**Design Addendum**

For Reselton Properties

This Design Addendum has been prepared in direct response to a series of comments provided by London Borough of Richmond Upon Thames regarding the submitted proposals for the former Stag Brewery site in Mortlake.

Proposed second floor plan of Buildings 5 and 6

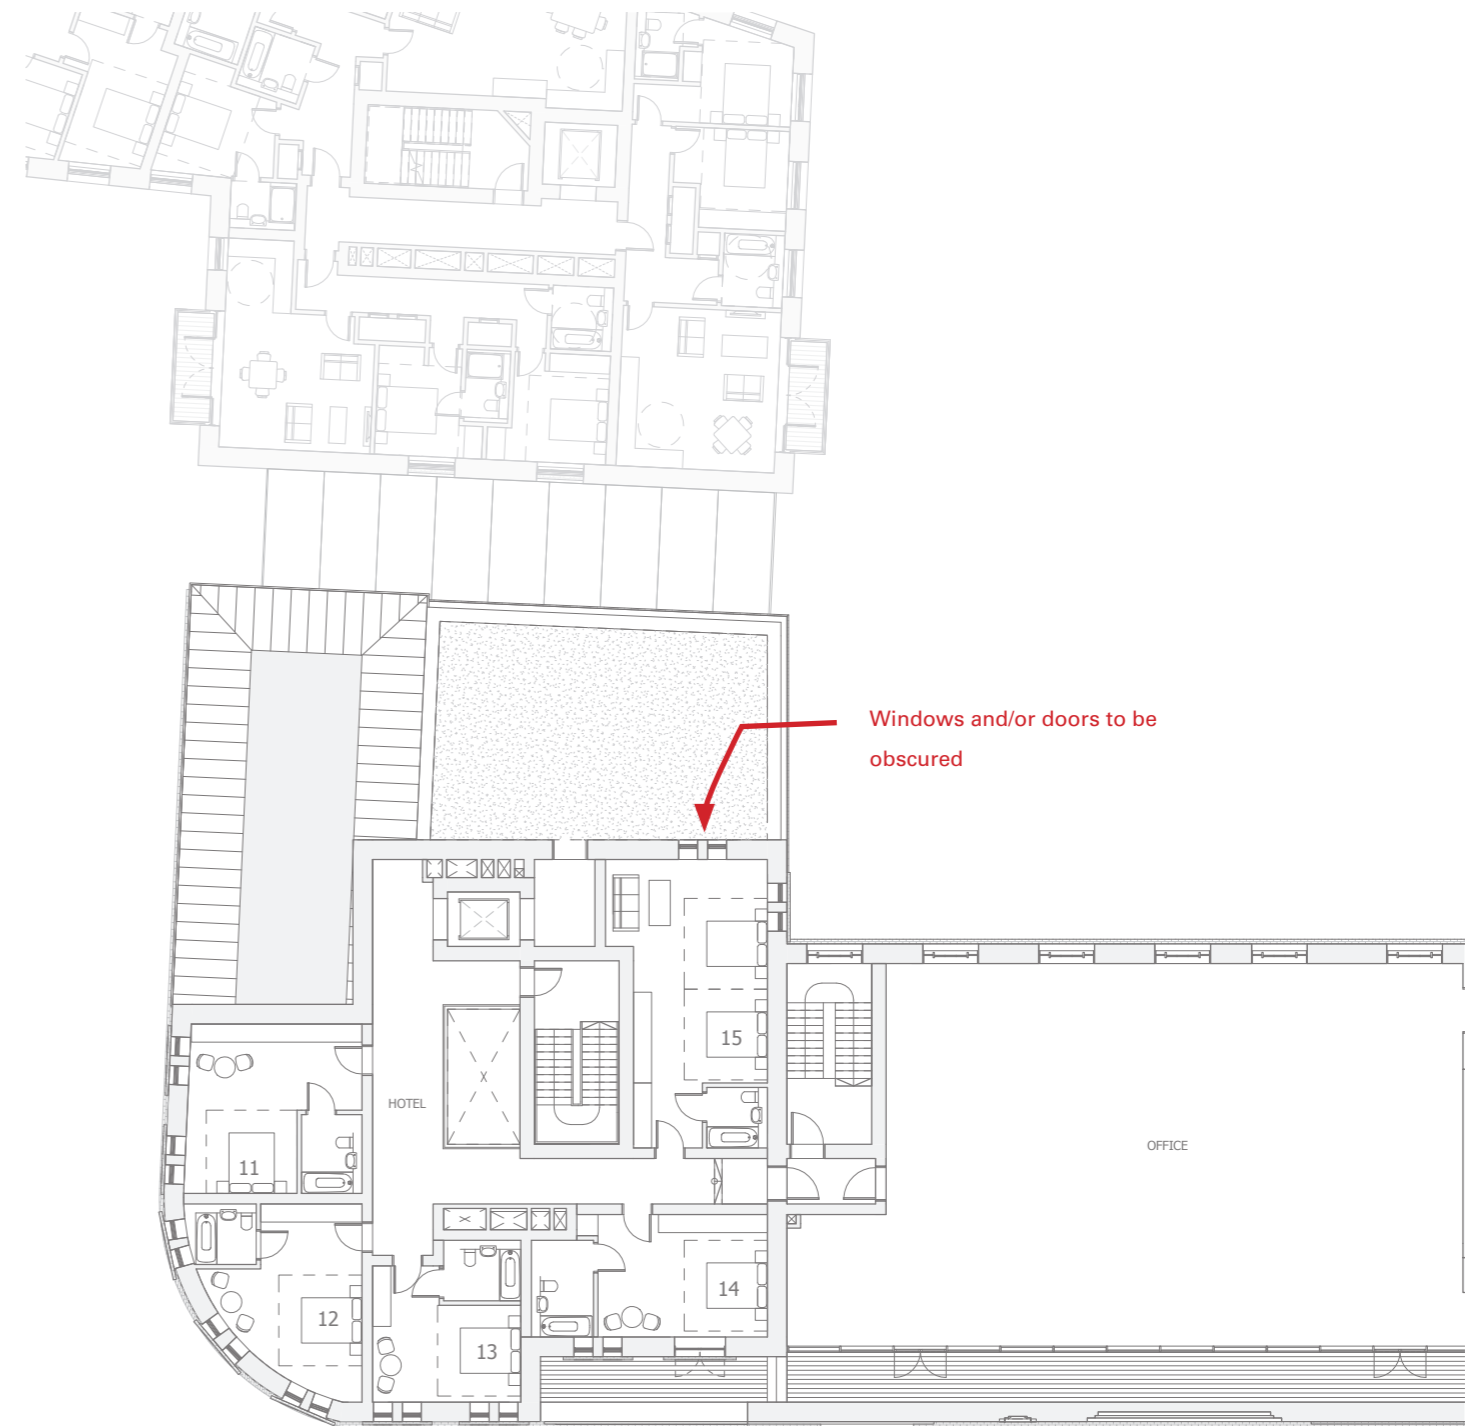
13. Block 6 and Block 5: only 4m gap between flat and wall. Unacceptable.

The 4 metre gap between the buildings is sufficient to clearly separate and distinguish the massing of Building 6 from the hotel building. The only windows that overlook from Building 5 towards Building 6 are to the set back elevation at second floor level of the hotel – we will be amending the elevation to either omit or obscure the hotel windows that face Building 6.

Proposed ground floor plan - Building 9

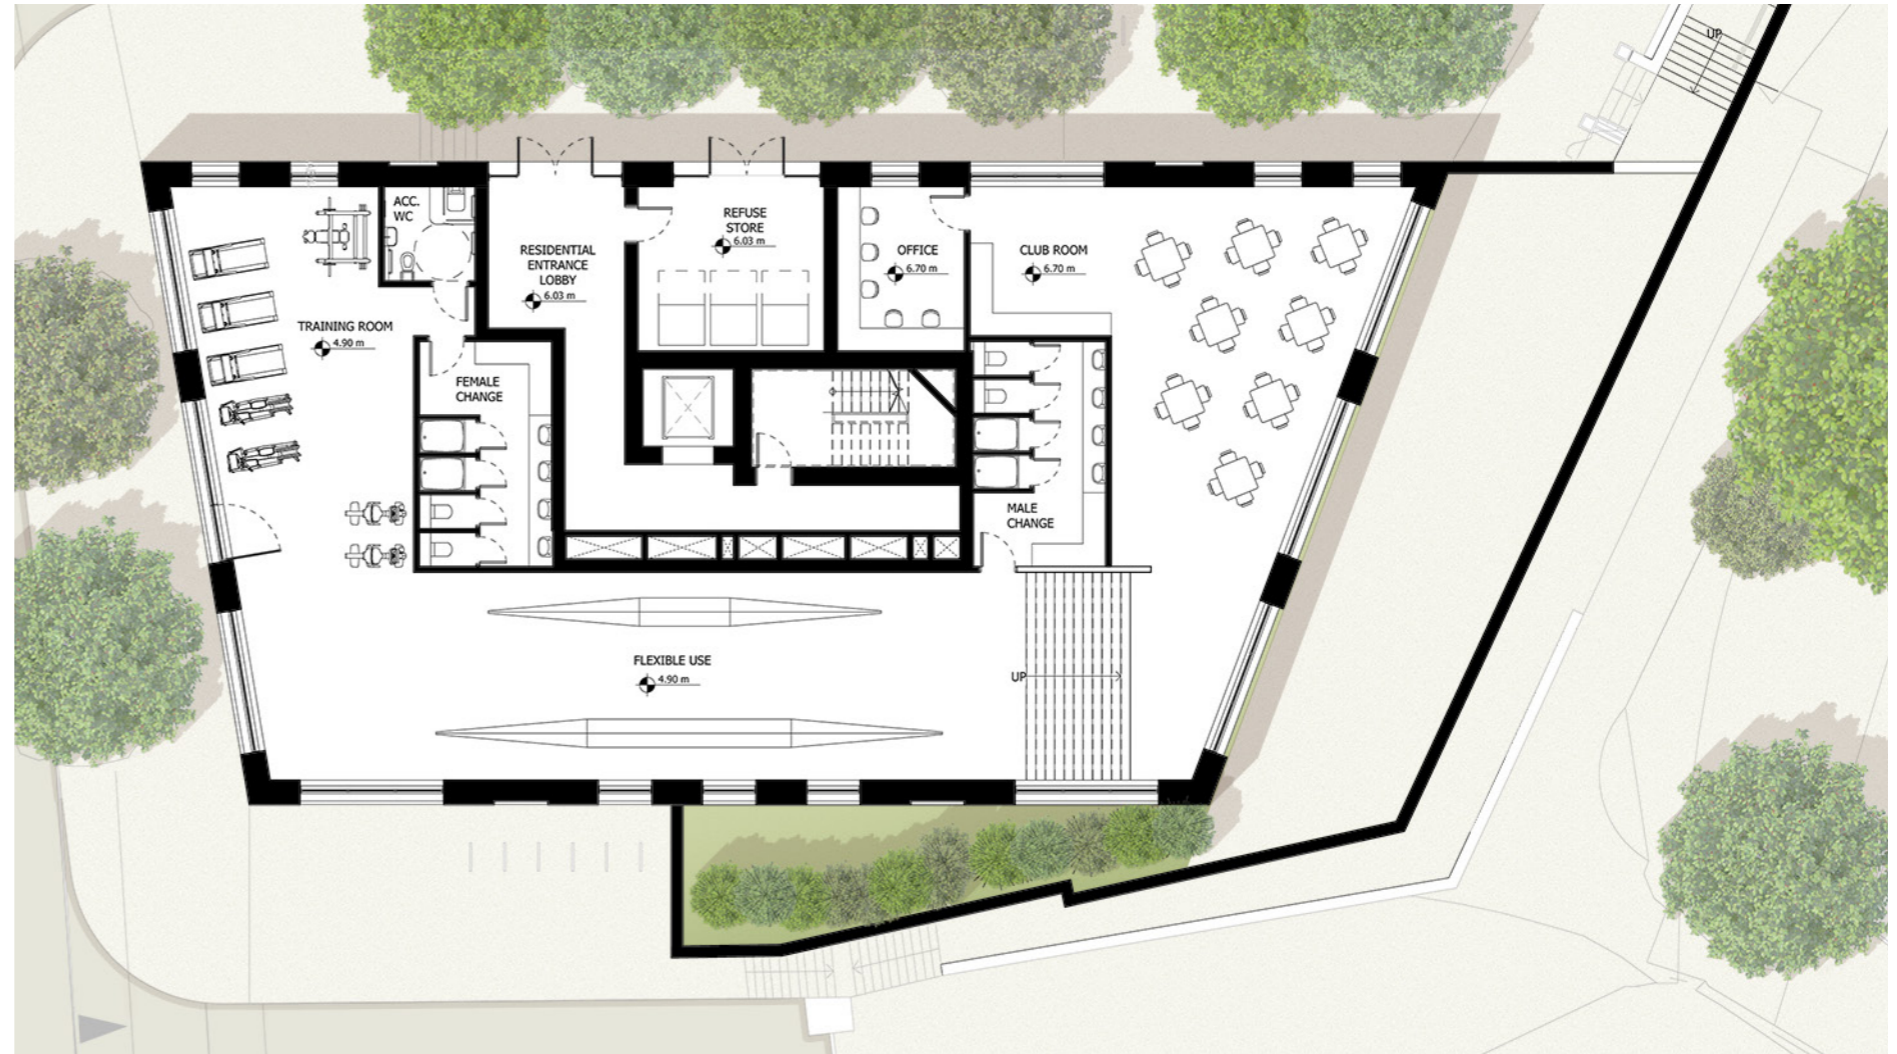
4. Ensure plant is at centre of roof level.

The roof top plant has already been configured in a manner that provides minimal impact to the appearance of the building. The parapet level facing Mortlake High Street masks the roof top plant from view.

Revised north elevation - Building 10

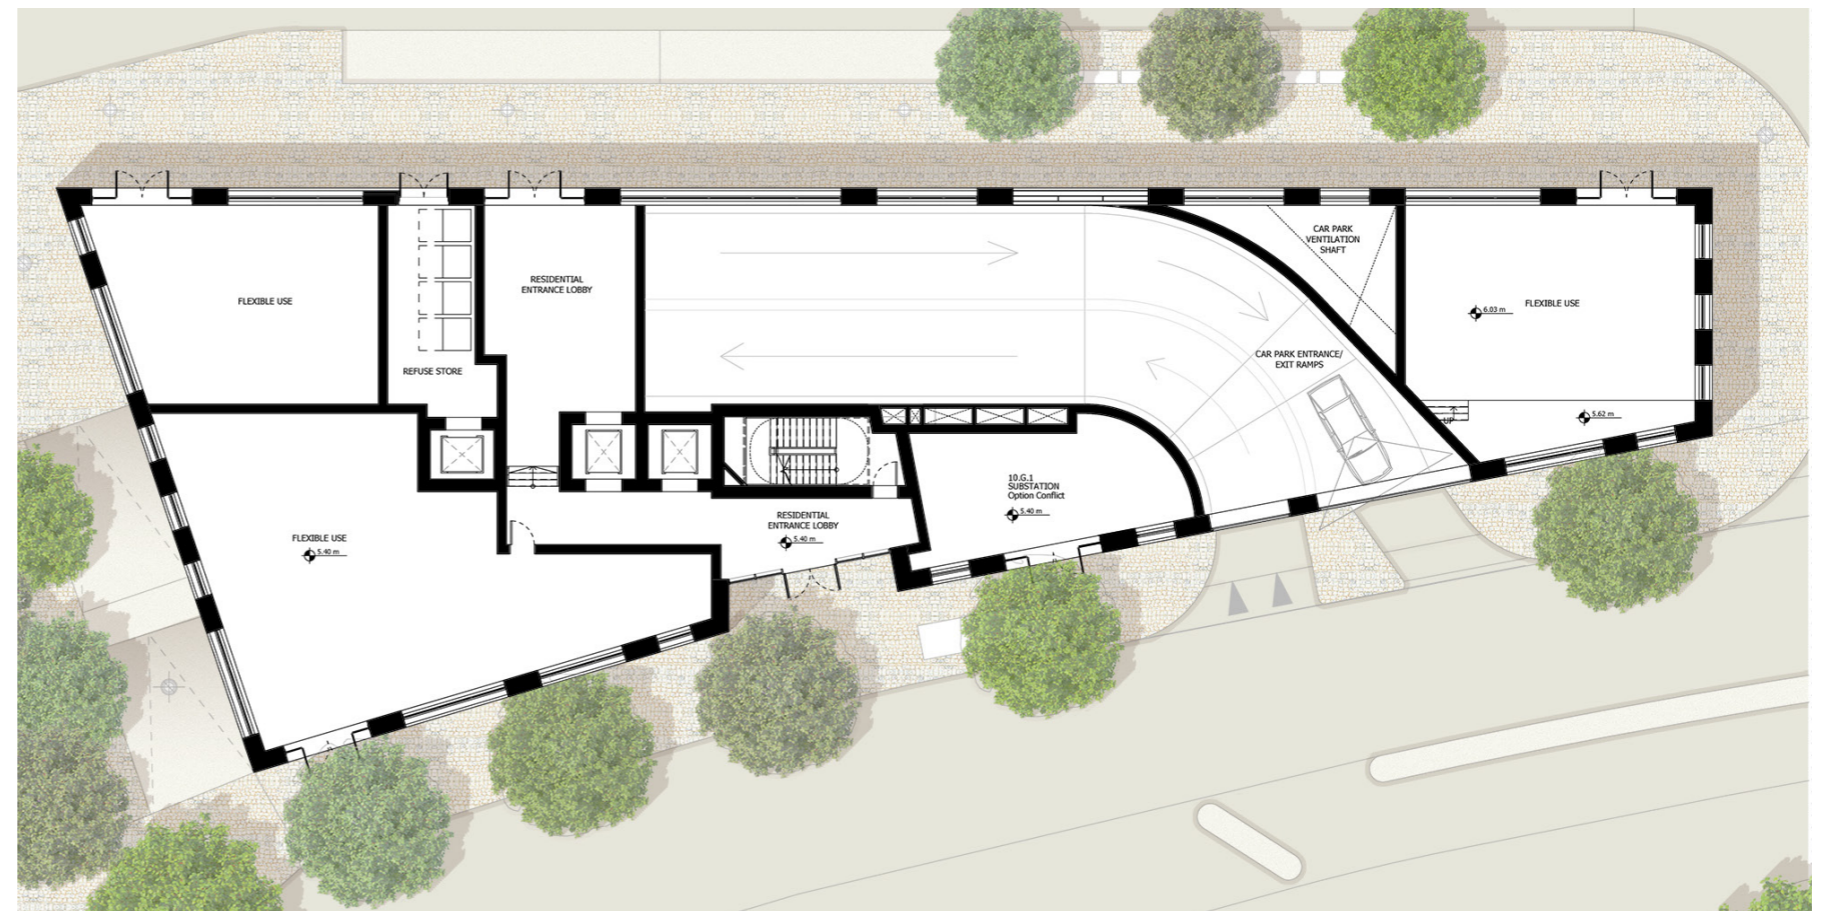
2. South elevation – broken up with glazing. This works successfully – something more radical is needed for Block 7 in particular.

We believe that it would be inappropriate to break-up the length of mansion Building 7 with a glazed link. We have carefully crafted a contemporary version of the historic mansion typology that was extensively built during the Victorian era to deliver extensive new housing stock to a higher density. We believe the glazed link (which would need to be at least seven storeys high) would sit uncomfortably with this already very varied and undulating elevation.

Proposed typical floor plan - Buildings 11 and 12

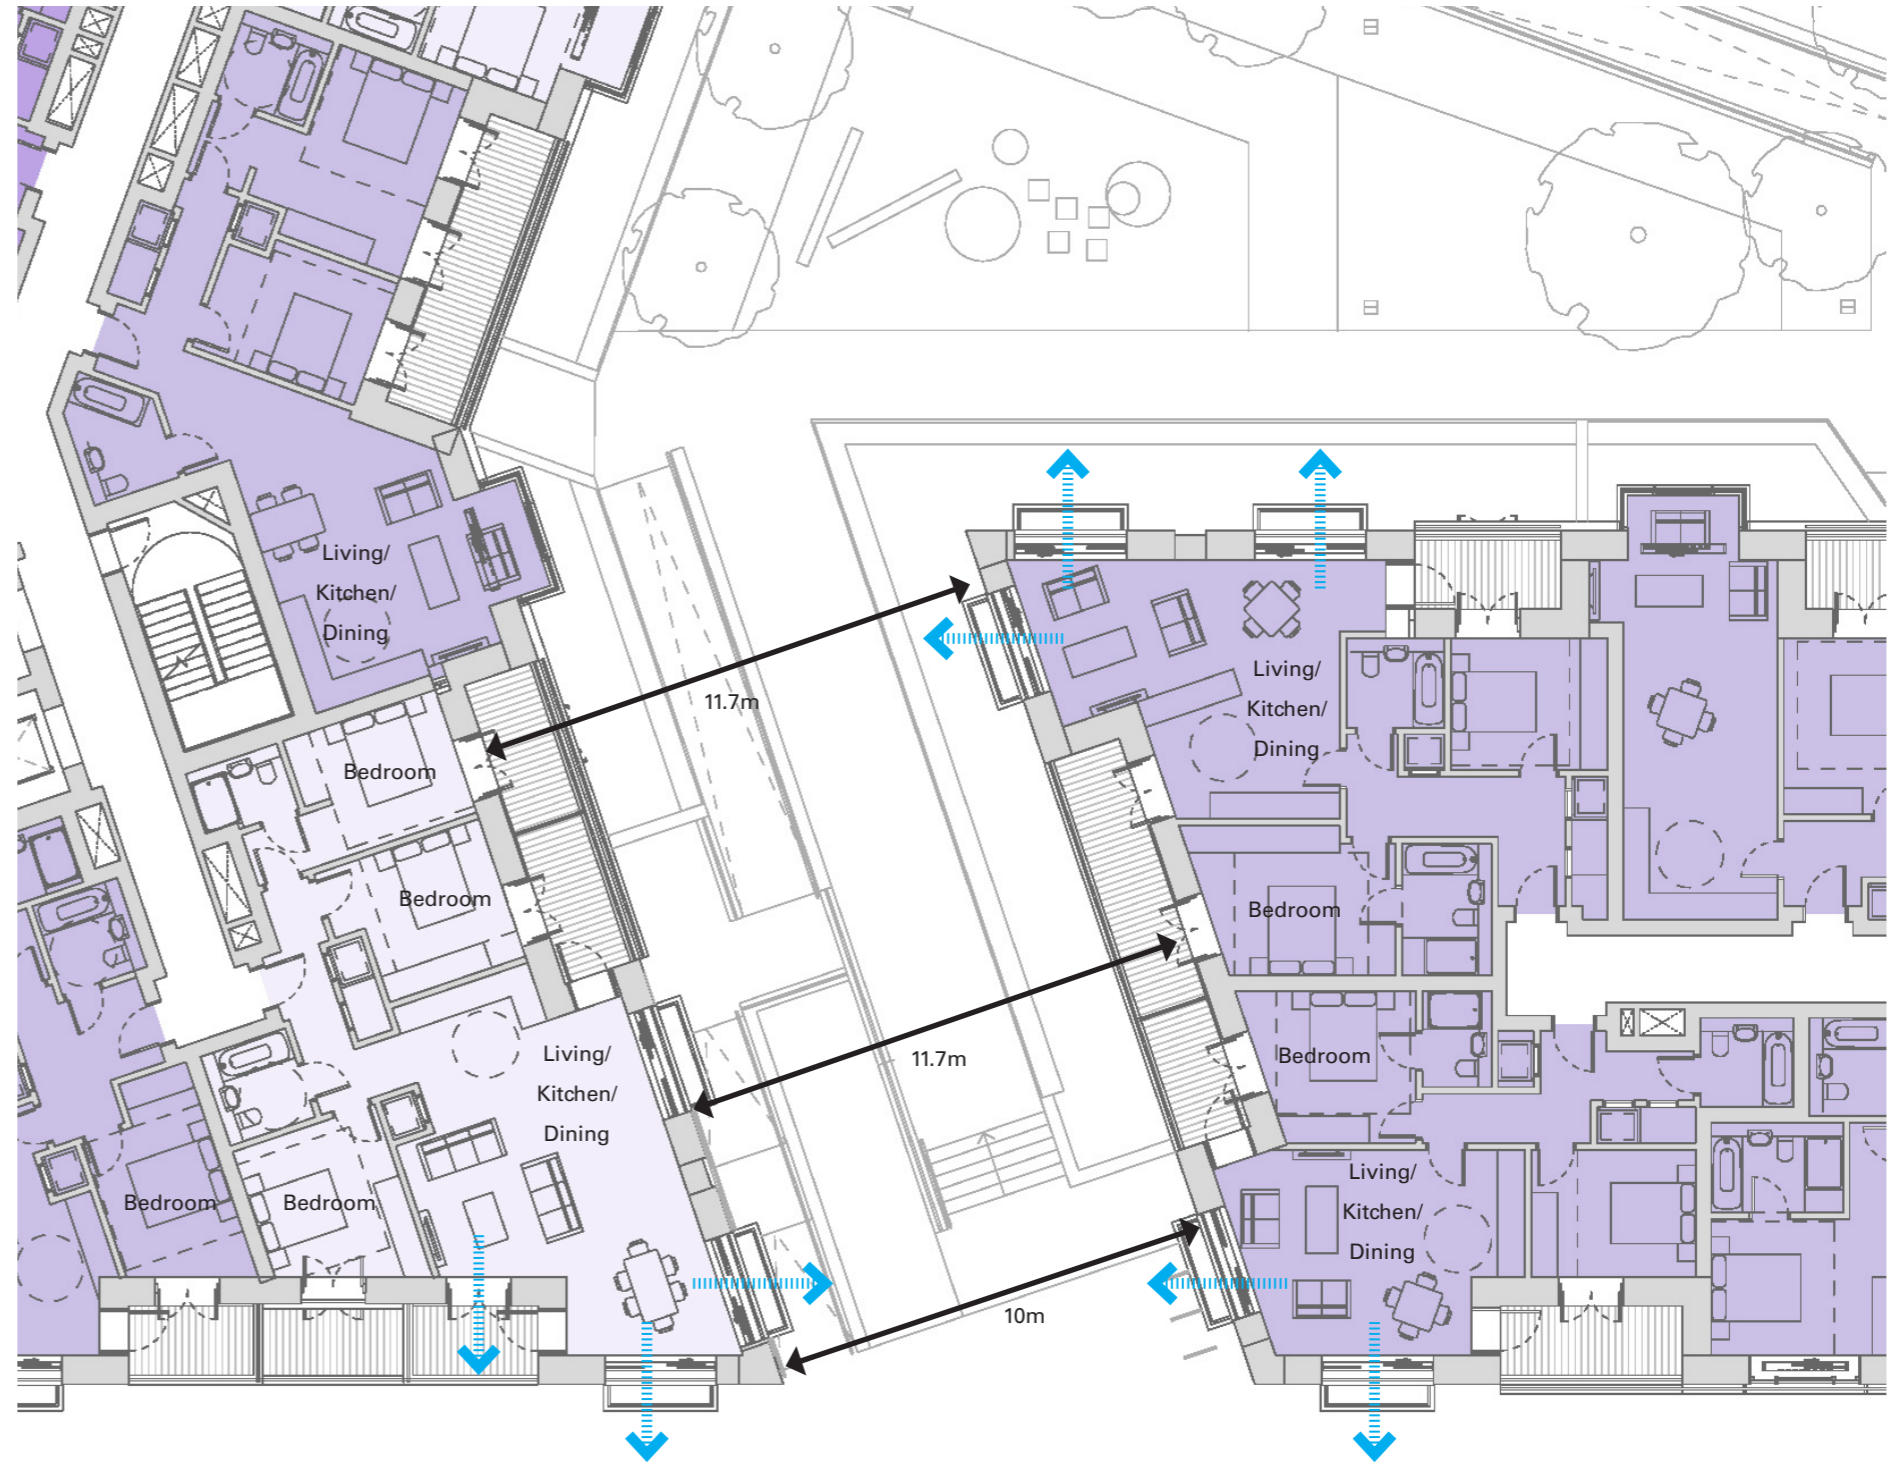
2. Block 11 with Block 12: Only 10m gap between and single aspect. Unacceptable living conditions.

Please refer to response to item 14 on Building 6 for an explanation of street widths.
